Ref: 188-002-007L

111 – 119 Port Douglas Road, Port Douglas – Civil and Electrical Works OP 2021-4246/1 Response to Information Request

We refer to Council's information request dated 9 August 2021 (copy attached) for the abovementioned application and respond to each of the items below.

DRAWN BY	CW	CW	OVER 50s RESIDENTIAL DEVELOPMENT	
	DJW	CHECKED	DJW	REVISION
DESIGNED BY	DJW	CHECKED	DETENTION BASIN DETAILS	
APPROVED BY	ORIGINAL CERTIFIED BY D.J.WALKER			A
	DRAWING NO.	188-002-C30		
	DATE: 26.06.21	REF ID: 19806

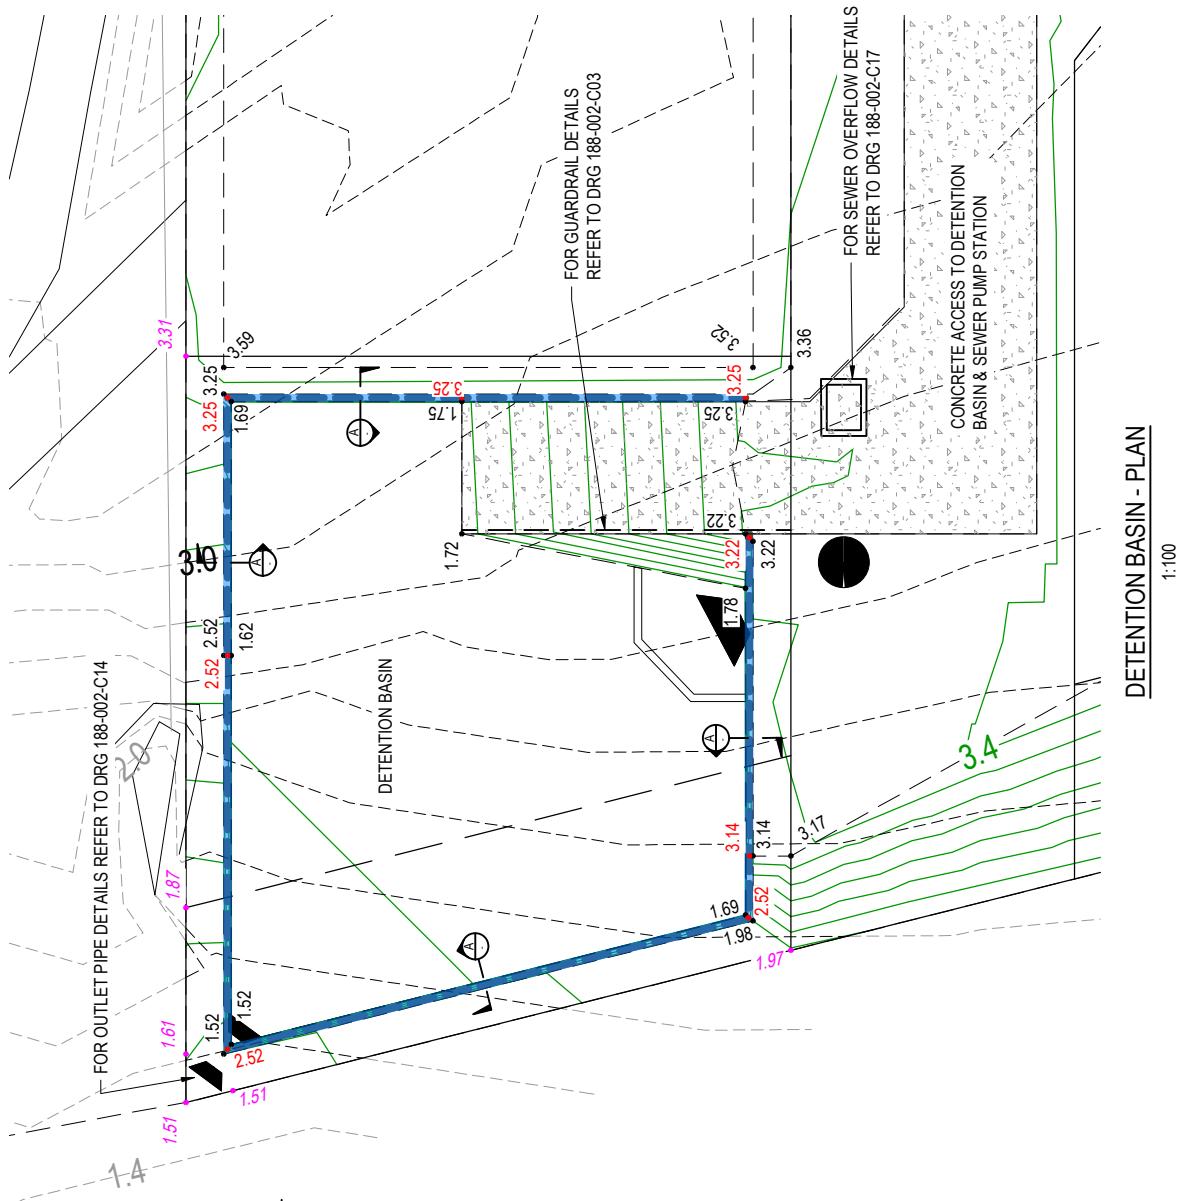
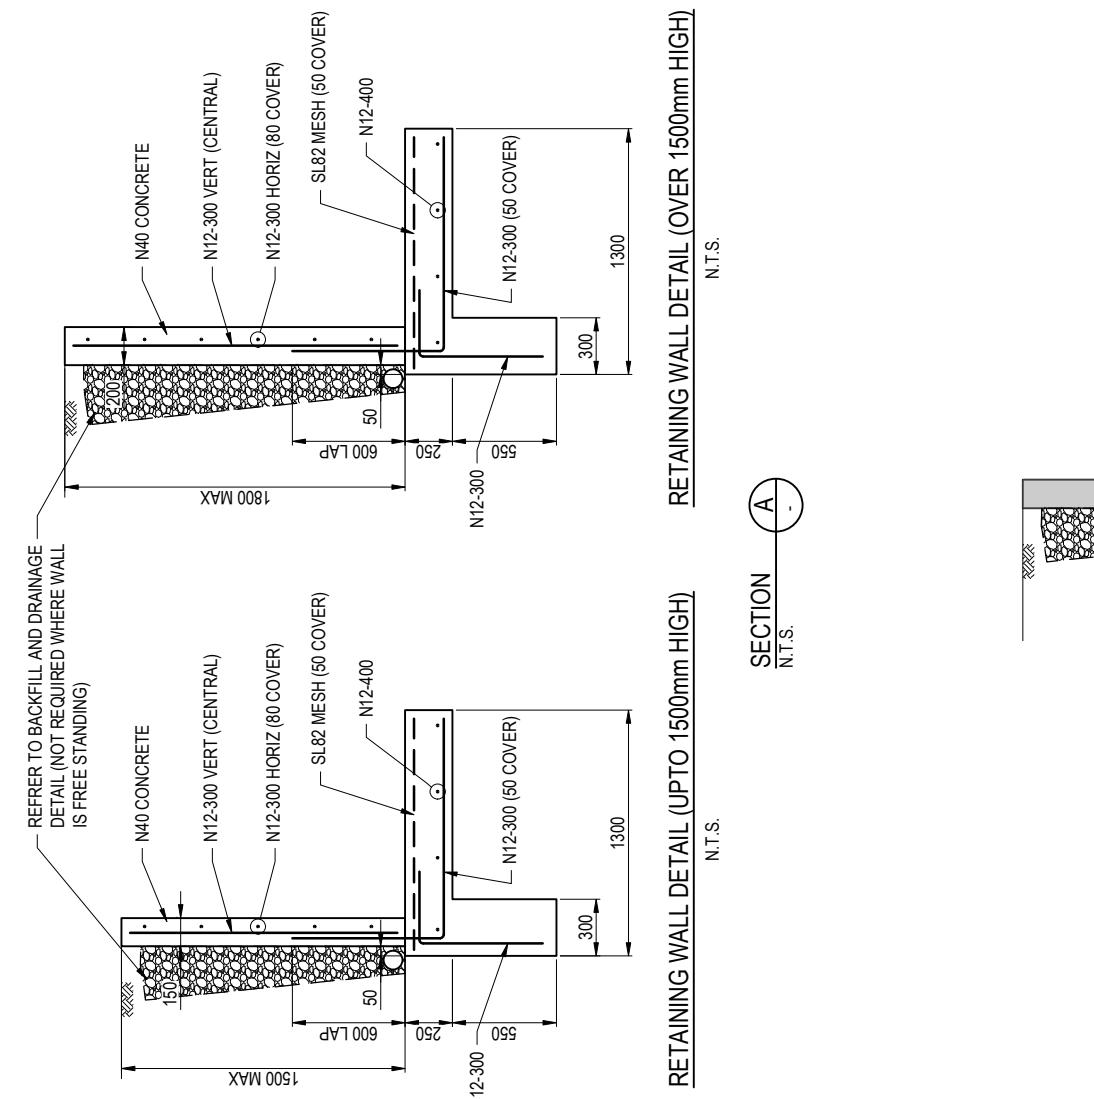
Item D

Refer to attached drawing 188-002-C30 that provides the details requested.
